**County of Loudoun**  
**Department of Planning**

**DATE:** January 25, 2010  
**TO:** BOS Transportation/Land Use Committee  
**FROM:** Jane McCarter, Project Manager  
Land Use Review Division  
**SUBJECT:** January 25, 2010 Transportation/Land Use Committee Meeting:  
CMPT 2009-0003; SPEX 2009-0004; SPEX 2009-0015 Scott Jenkins Memorial Park

Project Name/Subject: Scott Jenkins Memorial Park

**BOS TLUC additional information**

**Lighting Plan - Specific Accuracy of Projection Concerns-**

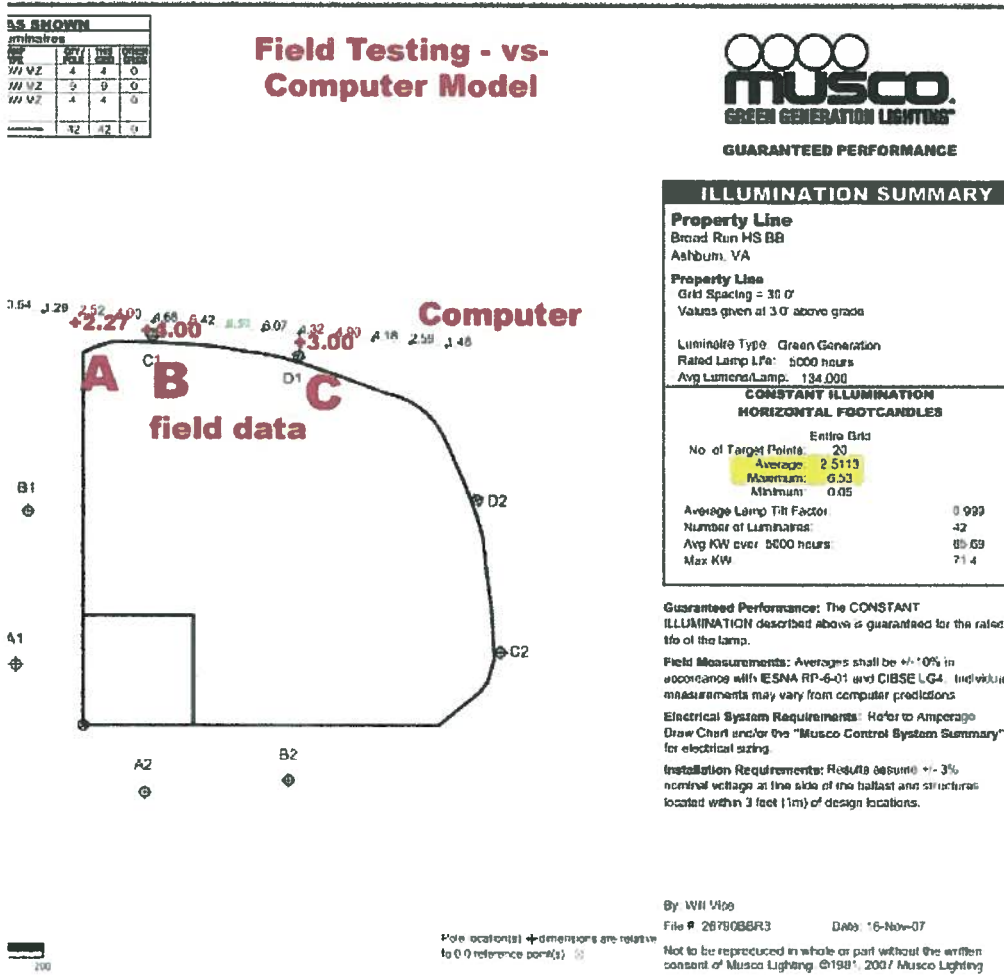
- Commissioner Austin recommended the applicant evaluate the accuracy of the computer model photometrics as compared to the actual field results of a similar lighting system (Broad Run High School)
- The field run comparison test was taken at the property line in locations that were pre-determined by the computer model for the new lighting at Broad Run High School.
- We took a several readings and determined that the computer model was accurate and, if anything, a bit conservative. The results are shown below
  - Point A computer model was 2.52 Footcandle (FC) while the field results were 2.27 FC.
  - Point B computer model was 4.68 FC and the field result was 4.00 FC.
  - Point C was 4.32 on the computer model and only 3.10FC in the field.

- The above findings conclude that the simulation is a conservative projection. The computer generated simulations are based on the fields in a wide open area with nothing blocking the lights in any direction. They are based on a perfectly flat grade. Any change in the grades or vegetation surrounding the fields or the greenhouse will help lower the simulation numbers.

All Fields Lighting Simulation

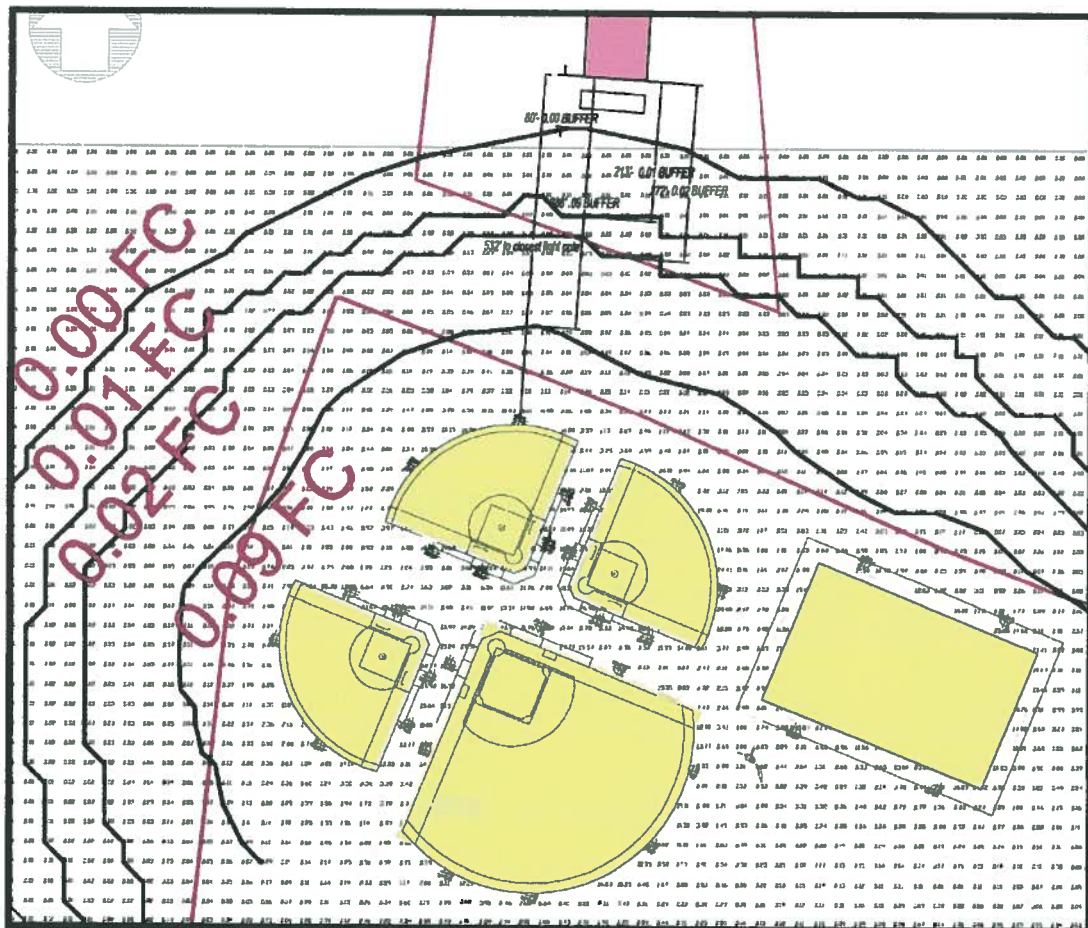
- a) The light meter used to create the data comparison and computer simulation for this application would need to be off by 18% for 0.01 footcandles to reach the nearest greenhouse used for poinsettia production.
- b) The light meter used would need to be off by 67% for 0.02 footcandles to reach the nearest greenhouse used for poinsettia production..
- c) The light meter used would need to be off by 264% for 0.09 footcandles, the minimum amount required to affect poinsettia production, to reach the nearest greenhouse used for poinsettia production.

**To put this in perspective, this would be the equivalent of driving 145MPH when your speedometer reads 55**

90° Diamond and Rectangular Field Lighting Simulation

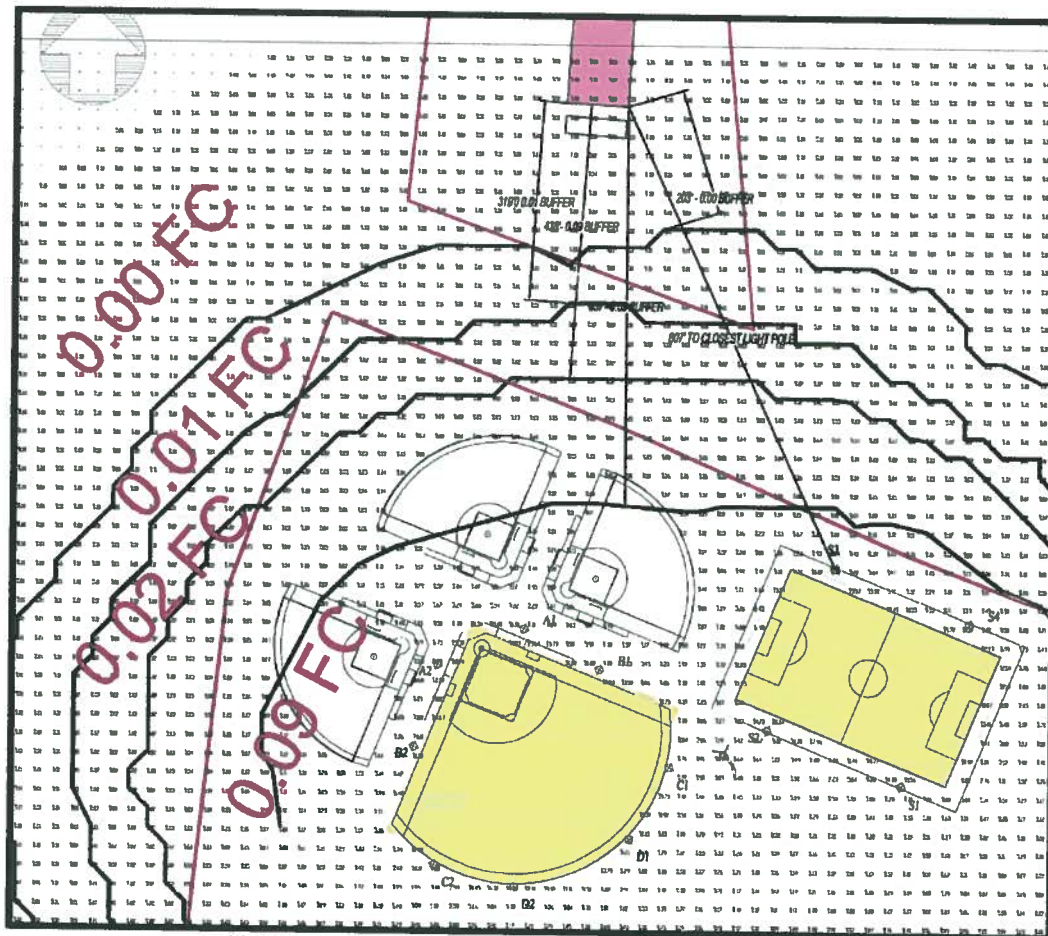
- The light meter used to create the data comparison and computer simulation for this application would need to be off by **34%** for 0.01 footcandles to reach the nearest greenhouse used for poinsettia production.
- The light meter used would need to be off by **65%** for 0.02 footcandles to reach the nearest greenhouse used for poinsettia production..
- The light meter used would need to be off by **375%** for 0.09 footcandles, the minimum amount required to affect poinsettia production [confirm], to reach the nearest greenhouse used for poinsettia production.

**To put this in perspective, this would be the equivalent of driving 206 MPH when your speedometer reads 55**

Single 90' Diamond Lighting Simulation

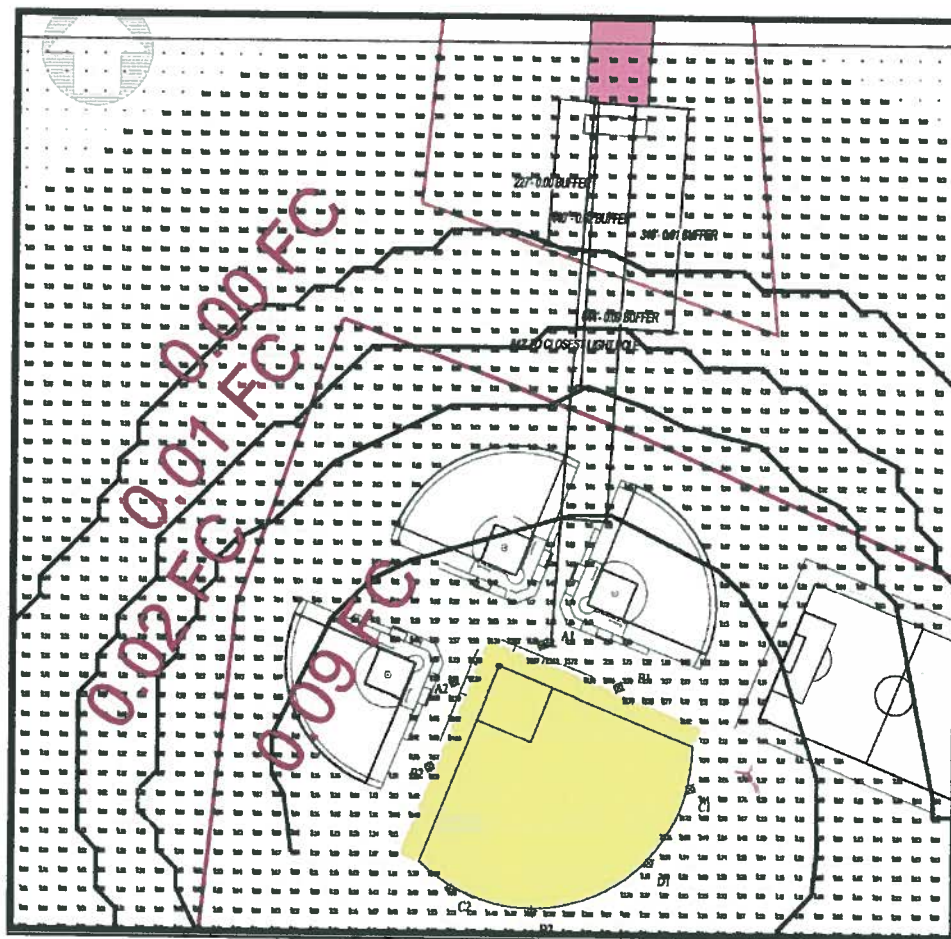
- a) The light meter used to create the data comparison and computer simulation for this application would need to be off by **37%** for 0.01 footcandles to reach the nearest greenhouse used for poinsettia production.
- b) The light meter used would need to be off by **70%** for 0.02 footcandles to reach the nearest greenhouse used for poinsettia production..
- c) The light meter used would need to be off by **325%** for 0.09 footcandles, the minimum amount required to affect poinsettia production [confirm], to reach the nearest greenhouse used for poinsettia production.

**To put this in perspective, this would be the equivalent of driving 178 MPH when your speedometer reads 55**
